HOMESTEAD NORTH AT STERLING RANCH FILING 3

GRADING AND EROSION CONTROL PLAN

STREET IMPROVEMENT PLAN

STORM PLANS

**DP01 PROFILE
STA 1+00.00 TO 10+06.62**

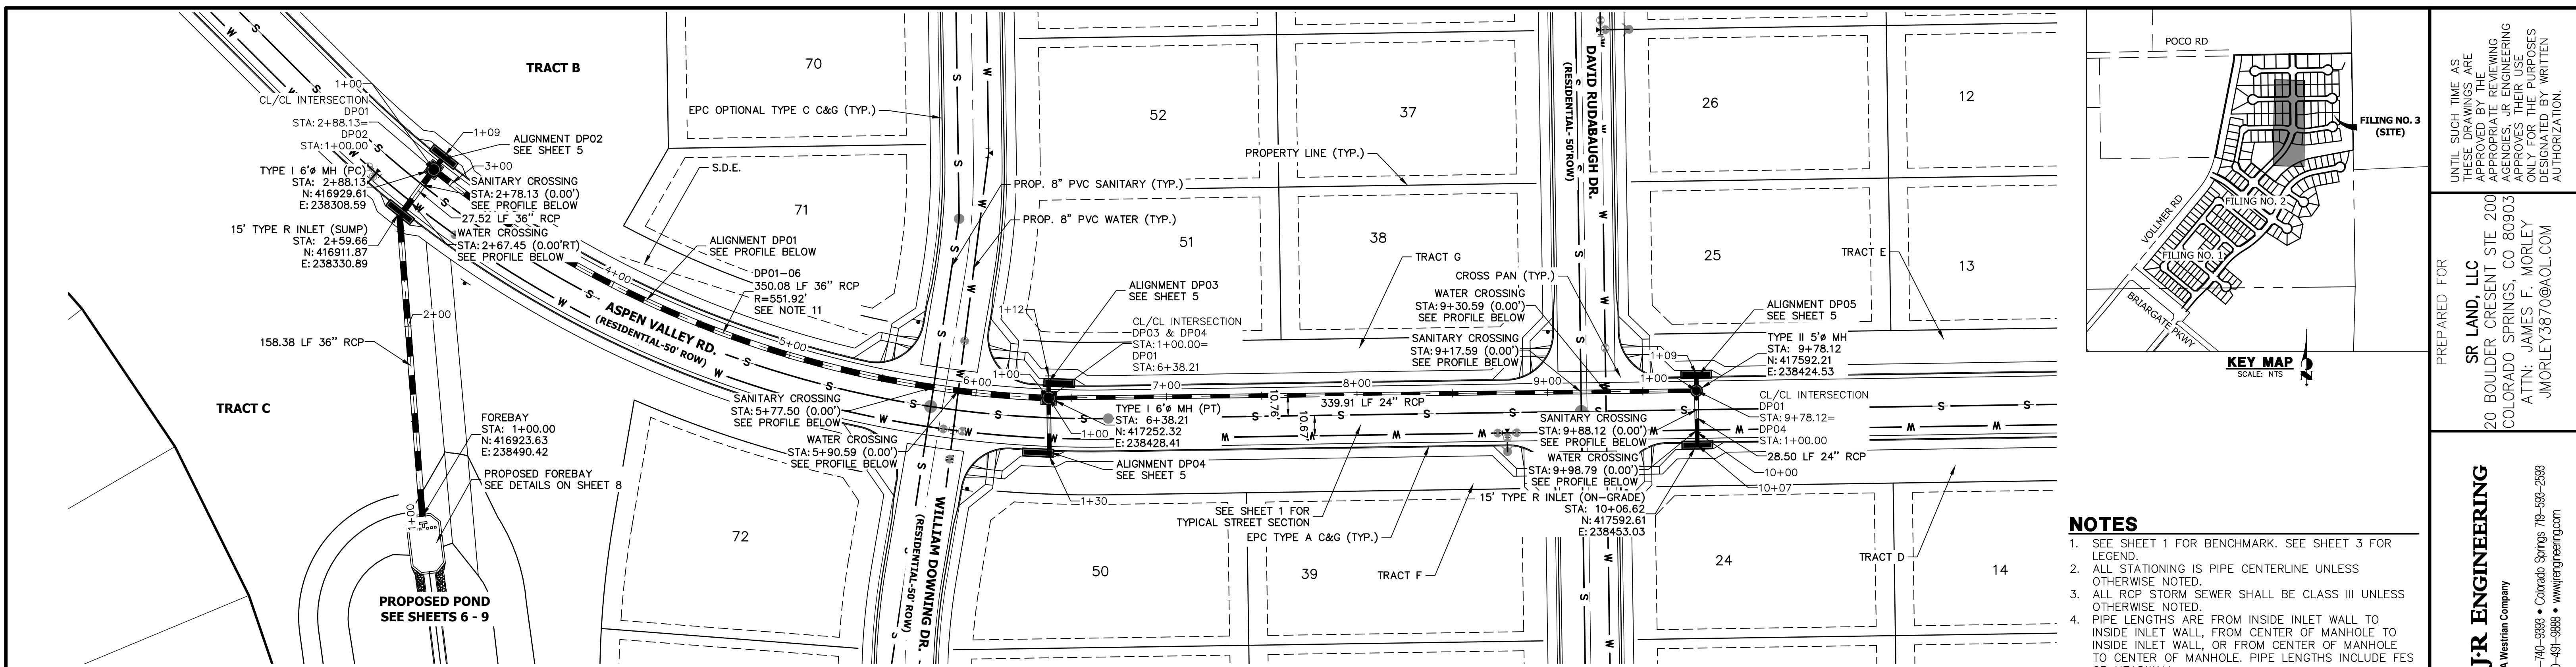
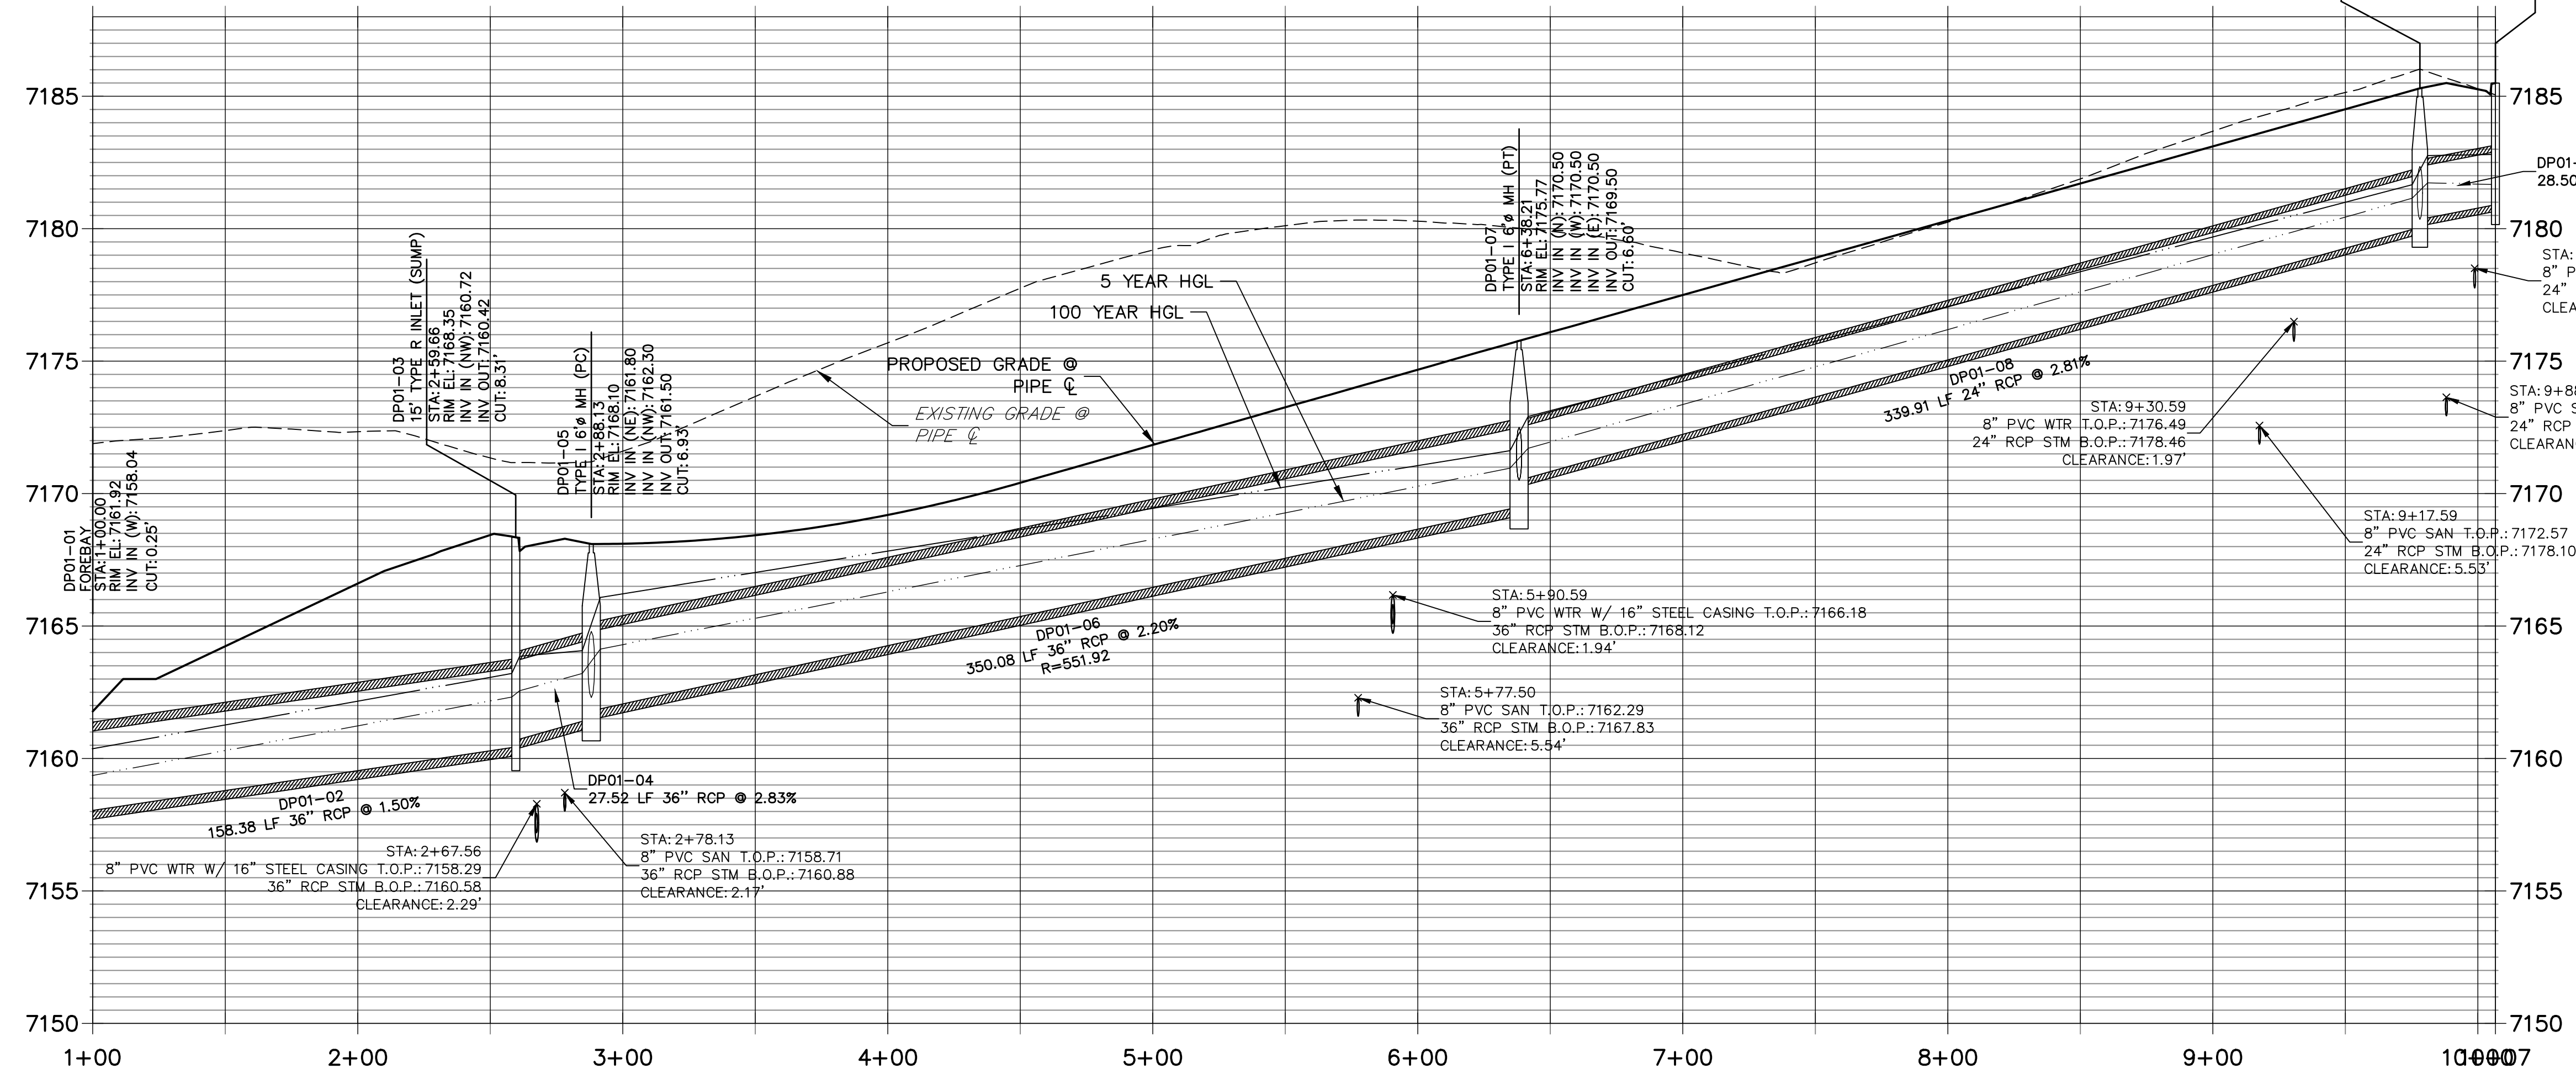
Storm Plan & Profiles will be reviewed with next submittal when Storm design (StormCAD) is provided

POND OUTLET STRUCTURE PLAN
SCALE: 3/8"=1'

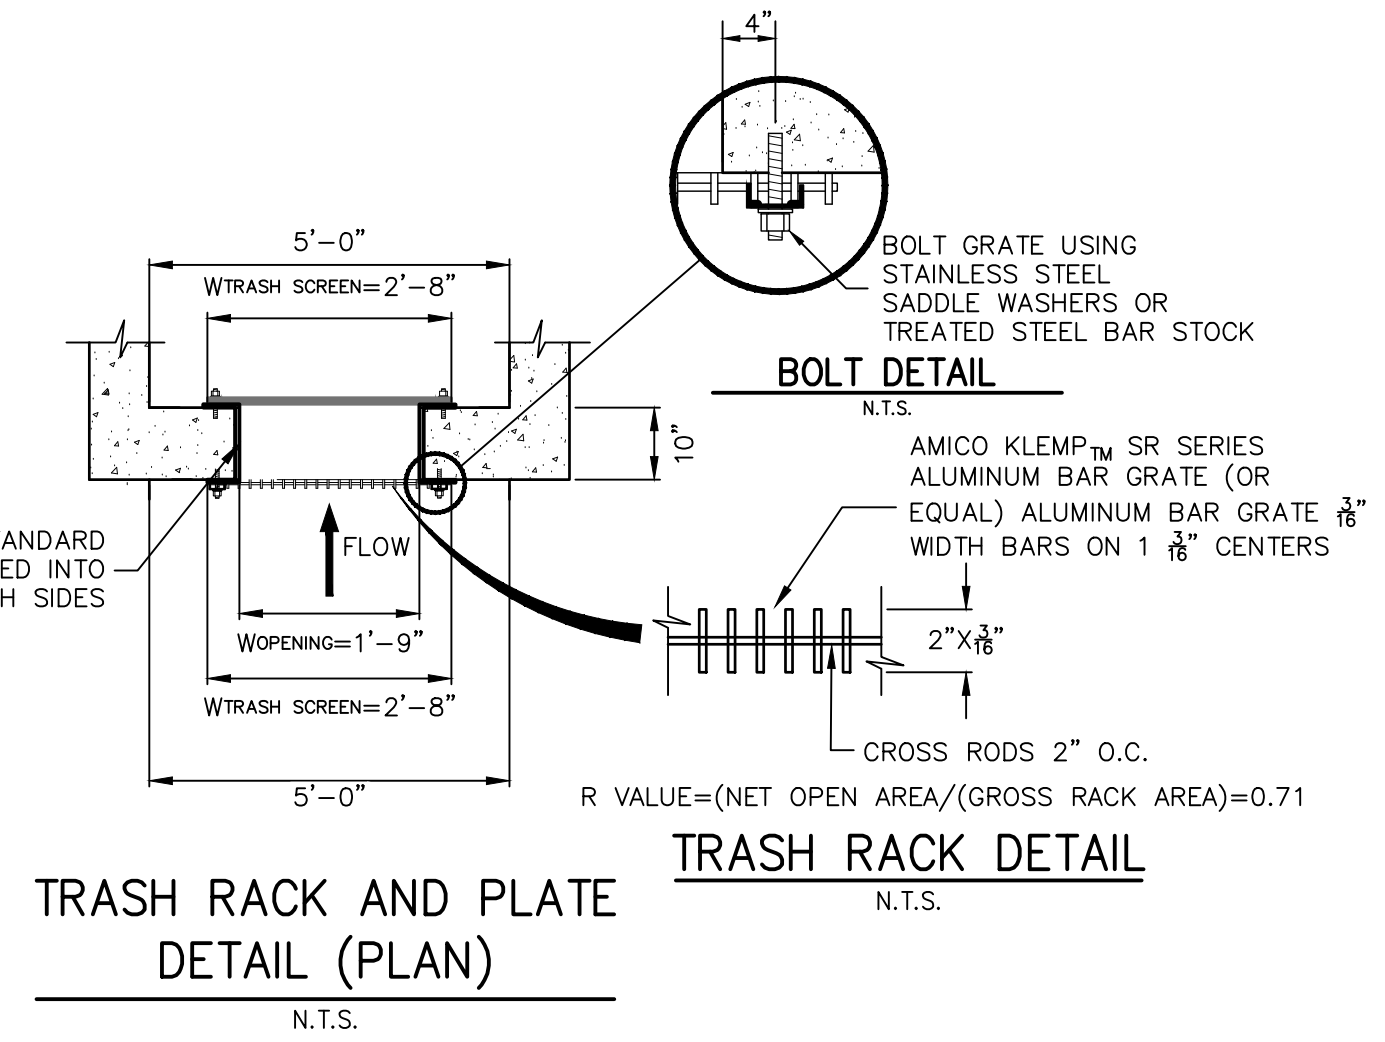
What are these dimensions for? appear to be in wrong place or need to be deleted
JR Response: Updated.

POND OUTLET STRUCTURE PROFILE
SCALE: 3/8"=1'

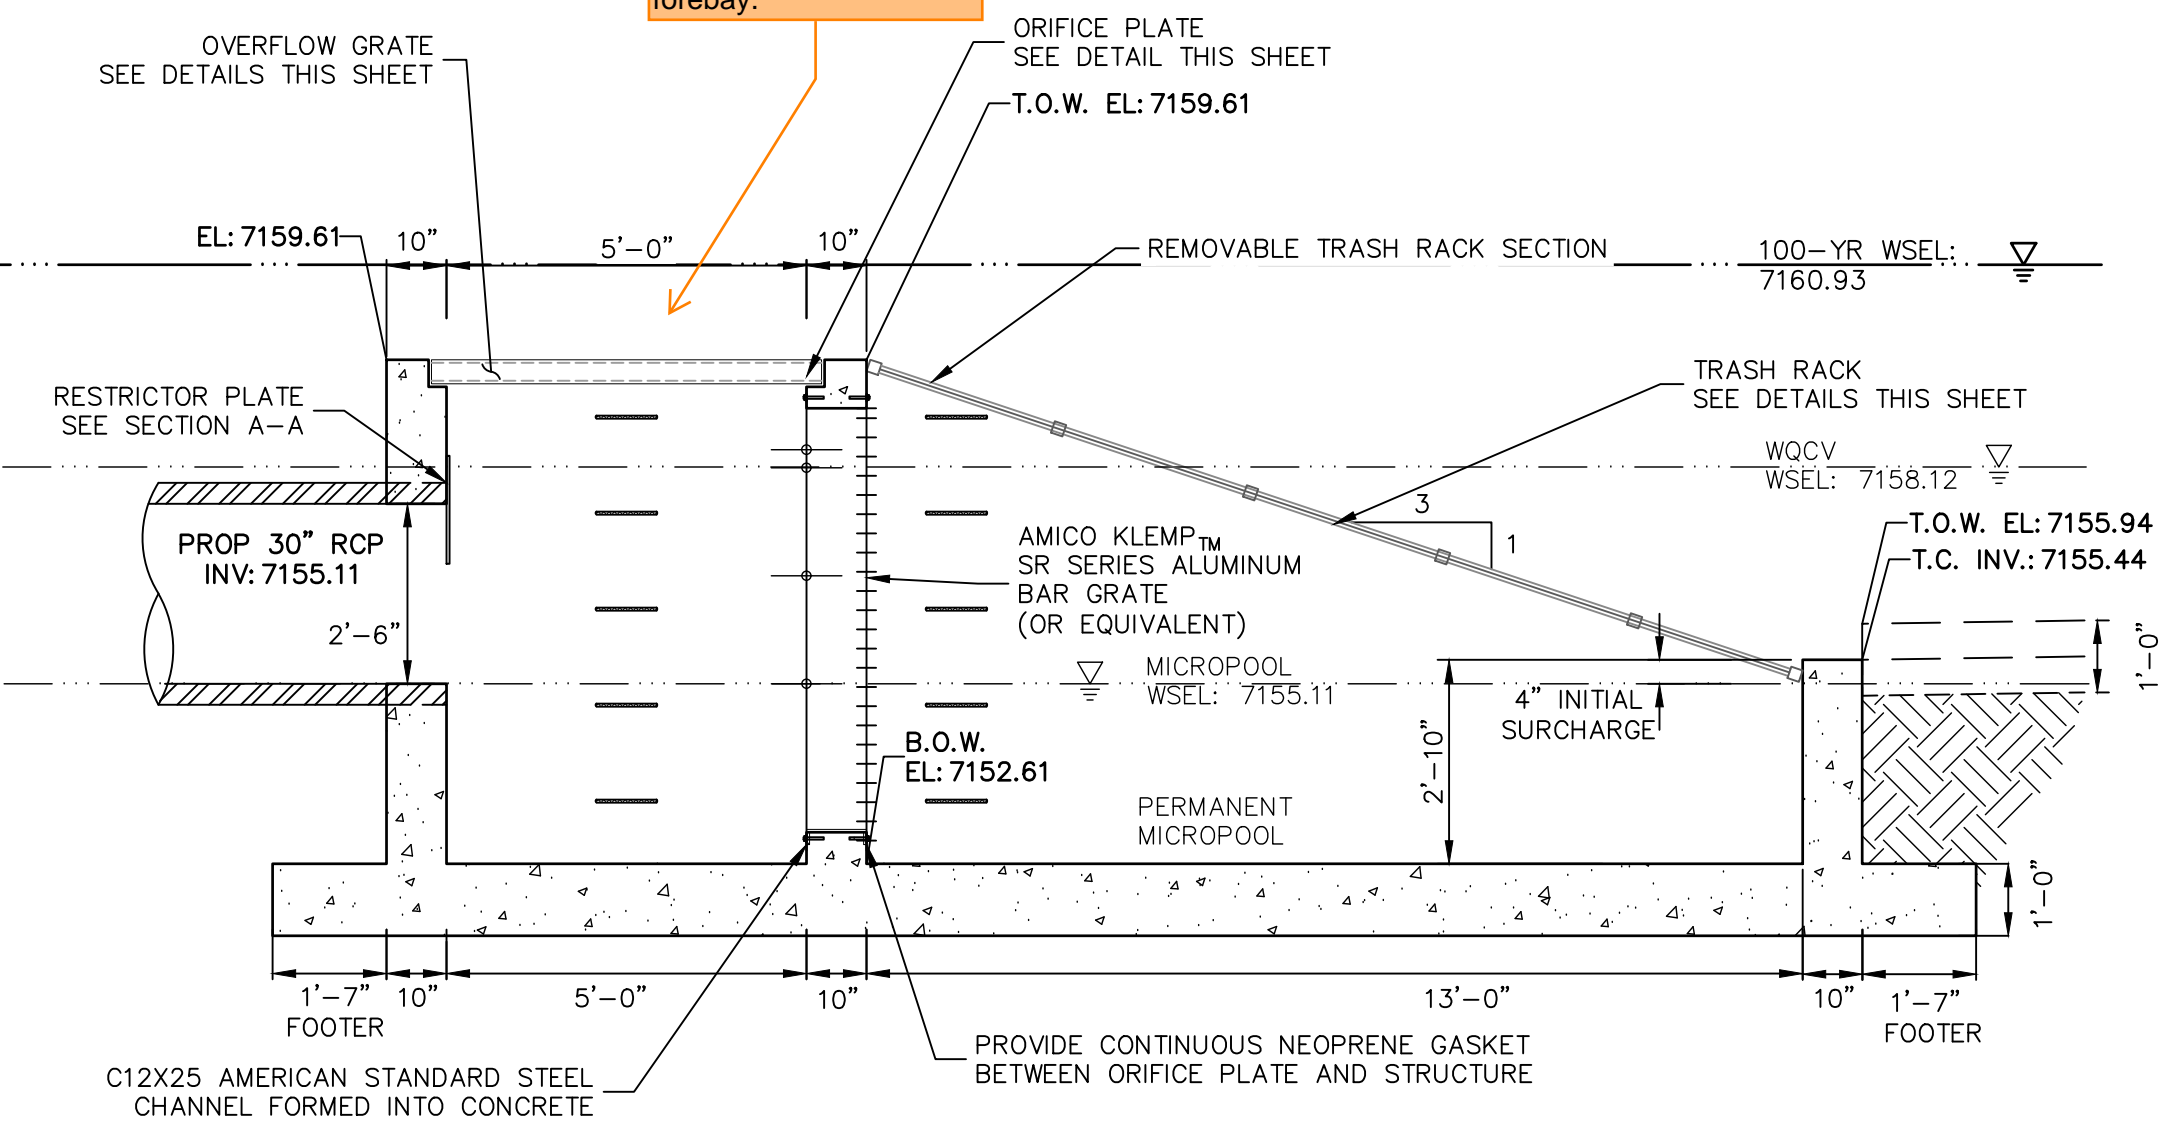
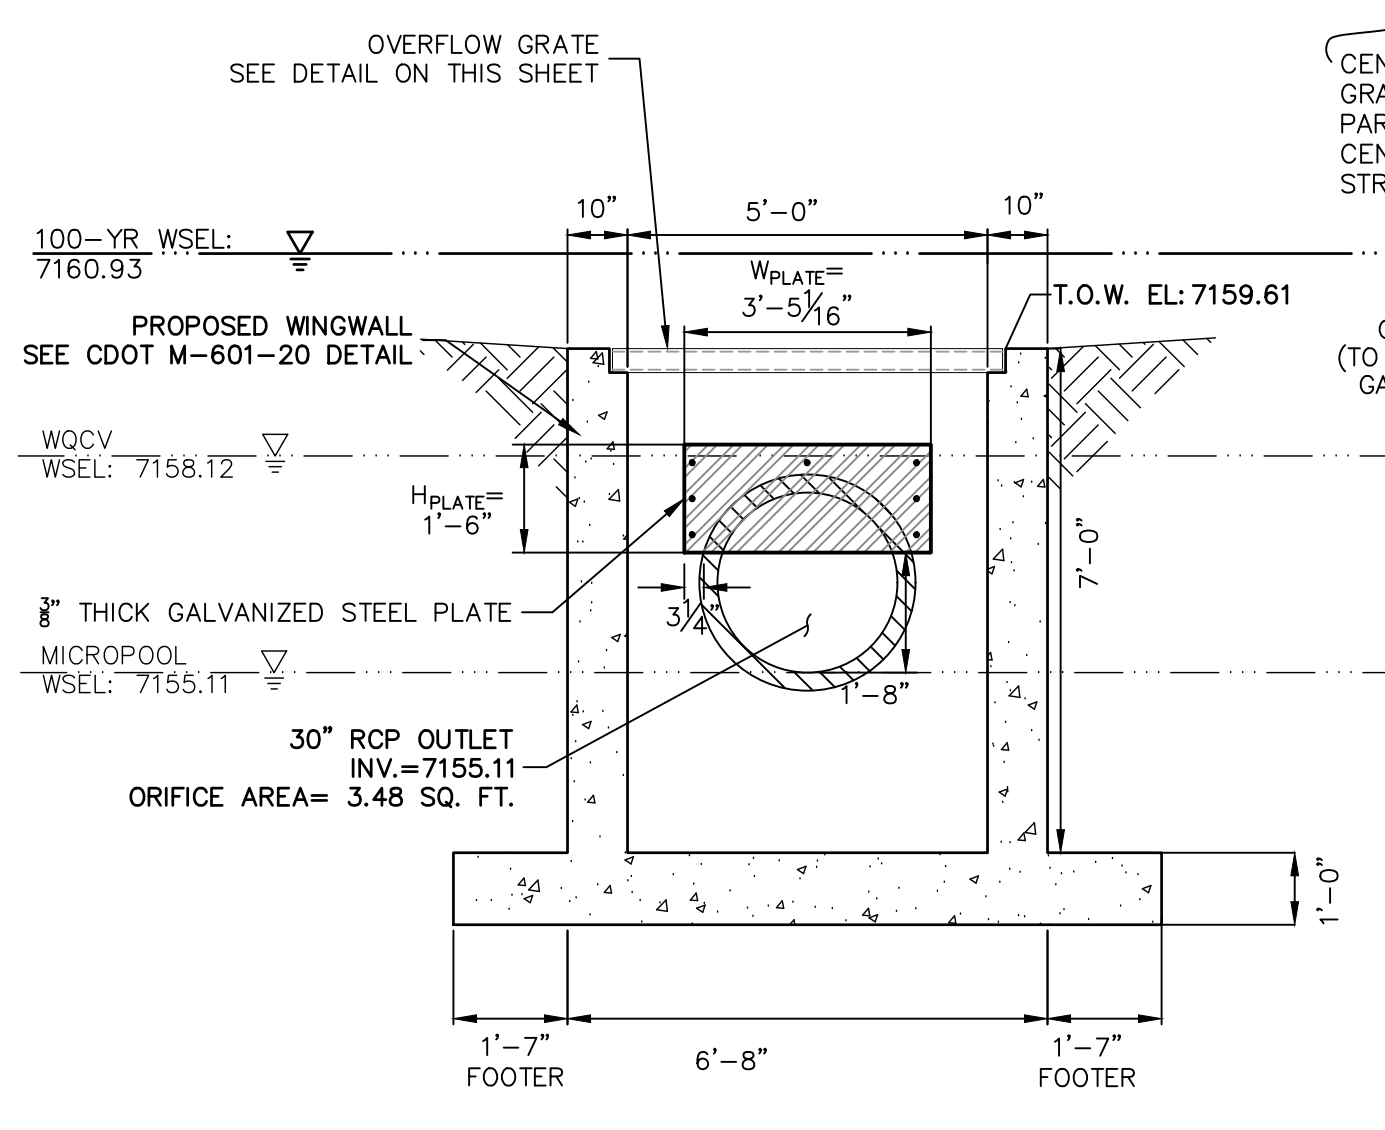
Consider need for safety railing around outlet structure similar to forebay.
JR Response: No need for safety measures given the trash rack, overflow grate, and elev. of surrounding surface.
